01	03.04.2020	CCP	ISSUED FOR COMMENT	10	P.18
02	10.04.2020	CCP	ISSUED FOR COMMENT	10	P.18
PRELIMINARY					
		TIER CONSULT: Richmond House, Sandpiper Court, Chester Business Park, Chester CH4 9JZ T: 01244 684 900			
Client		 TENSION CONTROL BOLTS			
Project TCB BUILDING EXTENSION, WREXHAM INDUSTRIAL ESTATE.					
Title PROPOSED DRAINAGE LAYOUT.					
Scale 1:2000/840	Drawn C.C. FITTON	Checked J. HALE	Revision P1		
Drawing No T_19_2265-55-01

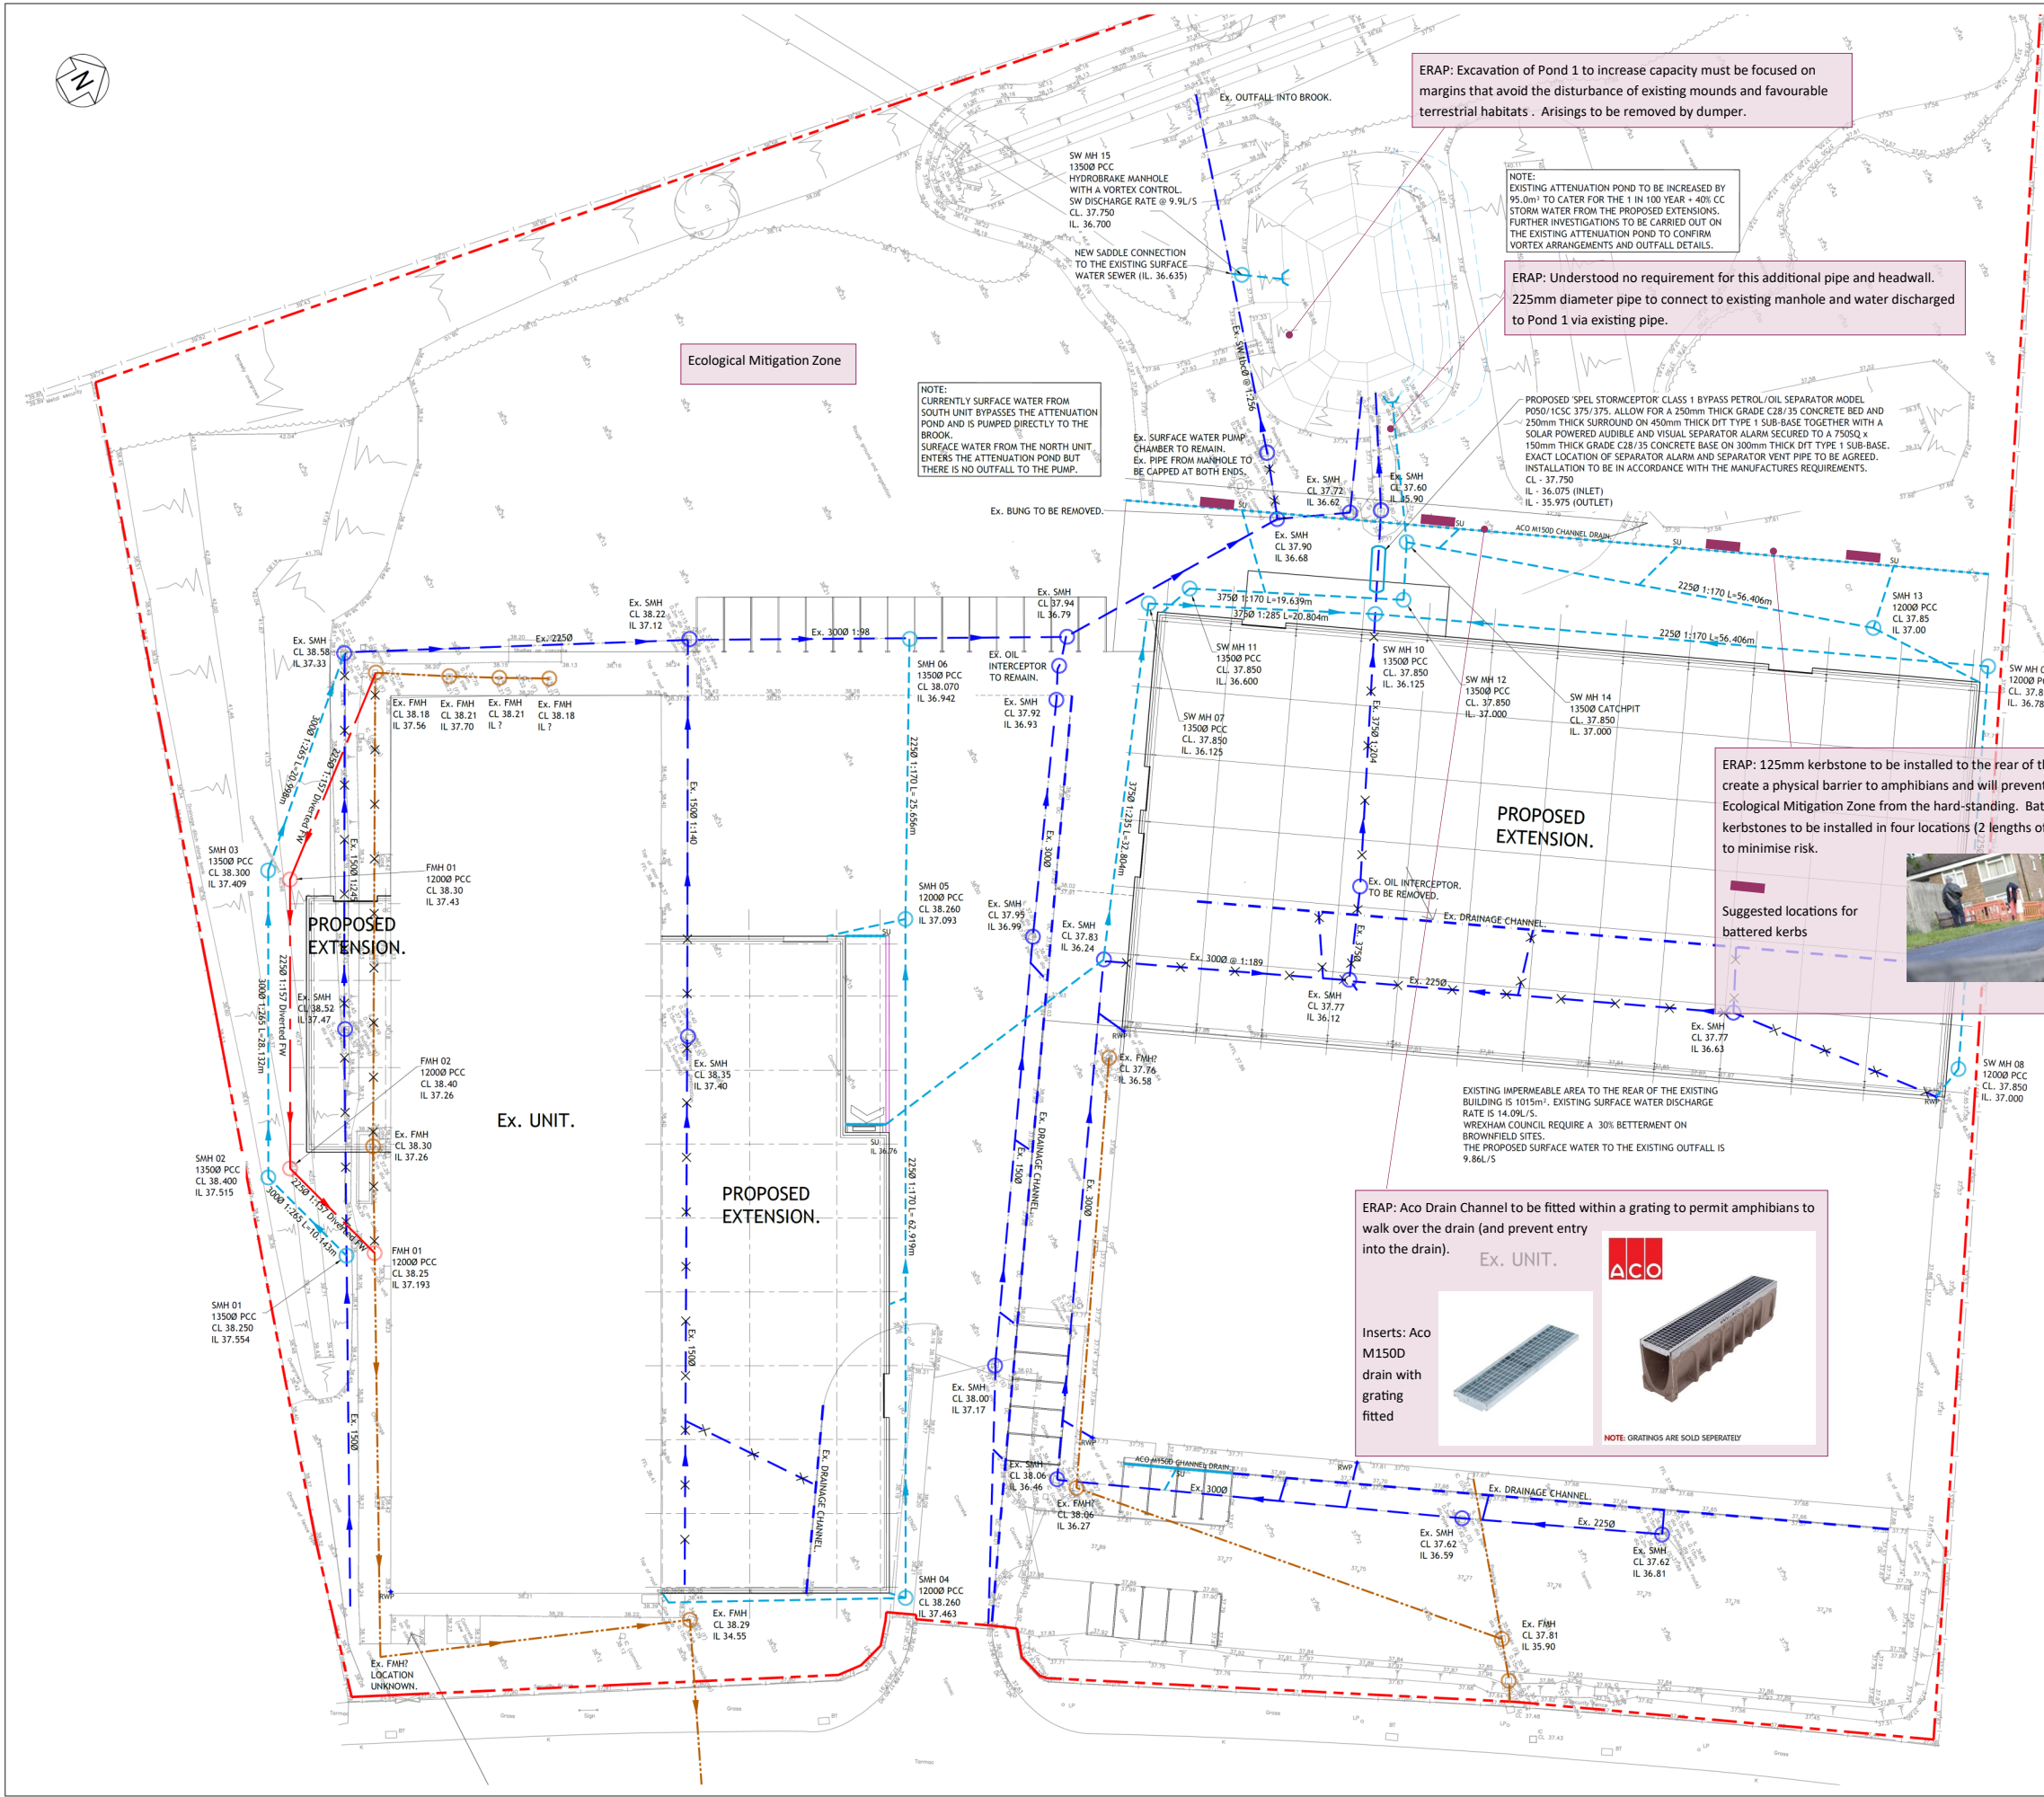
ERAP: Excavation of Pond 1 to increase capacity must be focused on margins that avoid the disturbance of existing mounds and favourable terrestrial habitats. Arisings to be removed by dumper.

ERAP: Understood no requirement for this additional pipe and headwall. 225mm diameter pipe to connect to existing manhole and water discharged to Pond 1 via existing pipe.

ERAP: 125mm kerbstone to be installed to the rear of the hard-standing will create a physical barrier to amphibians and will prevent any migration to the Ecological Mitigation Zone from the hard-standing. Battered / dropped kerbstones to be installed in four locations (2 lengths of 900mm = 1800mm) to minimise risk.

ERAP: Aco Drain Channel to be fitted within a grating to permit amphibians to walk over the drain (and prevent entry into the drain).
